Entergy Operations, Inc.
Waterloo Road
P.O. Box 756
Port Gibson, MS 39150
Tel 601 437 6470

Subject: Grand Gulf Nuclear Station
Docket No. 50-416
License No. NPF-29
Response to Request for Additional Information RE: Revision
of Technical Specifications for Emergency Diesel Generator
Lube Oil Inventory (TAC NO. MB0423) LDC 1999/083

Response to Request for Additional Information

Sketch #1

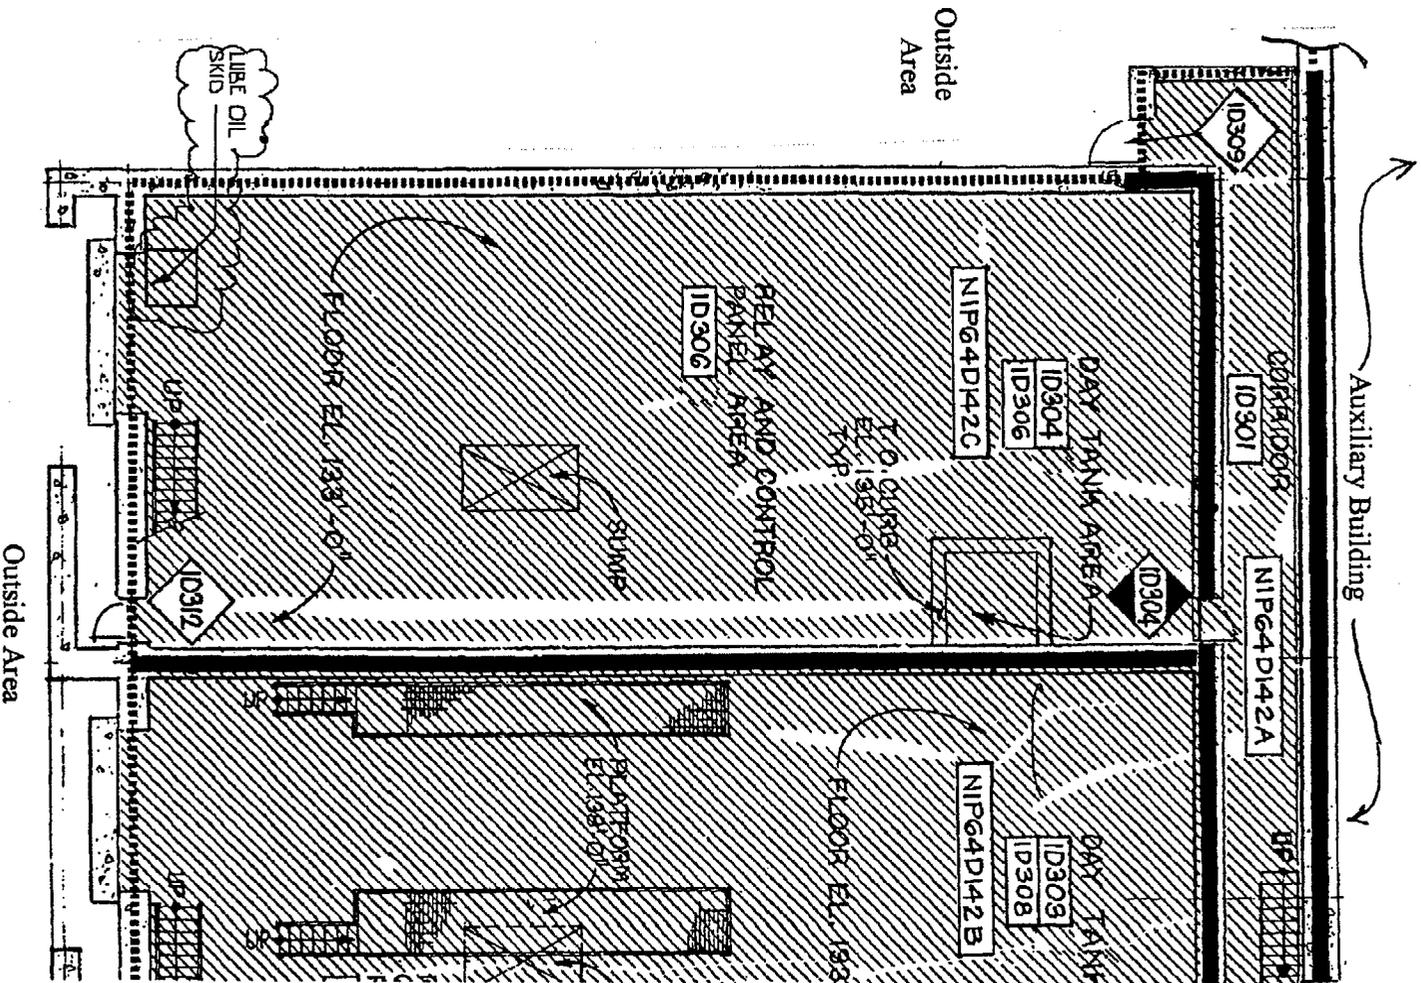
- b. Provide either a detailed diagram or detailed written description to describe the relationship of the lube oil storage skid and the Division I, II, and III EDGs to the following:
- combustibles
 - potential ignition/heat sources
 - safe shutdown equipment or cables
 - rated fire barriers/doors
 - automatic suppression and detection systems
 - manual fire protection features
 - ventilation systems

The lube oil storage skid will be located on the north end along the west wall of the Div. III EDG Room (Fire Zone 1A306/Fire Area 63) as indicated in Sketch #1. Sketch #1 is a partial view taken from Drawing A-0634 "Unit 1 Aux. & Diesel Gen. Bldg. and SSW Pump House – Fire Protection Floor Plans at El. 133'-0" & 139'-0". Fire Area 63 is separated from all other areas by

3-hour rated fire barriers and it contains no Appendix R safe shutdown components. The nearest combustibles to the lube oil skid are the lube oil in the west engine of the Div. III EDG (approximately 6' to the east) and electrical cables in trays (approximately 20' to the south and approximately 15' above floor level). The nearest fixed ignition source other than the diesel engine is electrical control panels located approximately 18' to the south of the oil storage skid. Protection for Fire Area 63 consist of area wide automatic pre-action sprinkler system, actuated by heat detectors, ultraviolet flame detection for early warning, and accessibility to manual hose streams and portable fire extinguishers. All suppression and detection system alarms annunciate in the main control room. The area where the oil skid is located is an open area that is adequately covered by the existing detection and suppression systems. Ventilation for this area consists of room supply fans with exhaust through the Diesel Generator Building Corridor (Room 1D301) to the outside. The major contributor's to the combustible loading in this area is the lube oil in the engines and diesel fuel oil. Currently the in situ loading is <45 minutes, the addition of the 3-55 gallon drums of lube oil and fill hose to this area increases the loading to <60 minutes. Fire Area 63 contains no safe shutdown components, total combustible loading will be <60 minutes, and this area is separated from other areas containing safe shutdown components by 3-hour rated fire barriers. Therefore, a fire in fire area 63 will not damage or propagate to damage redundant safe shutdown components.
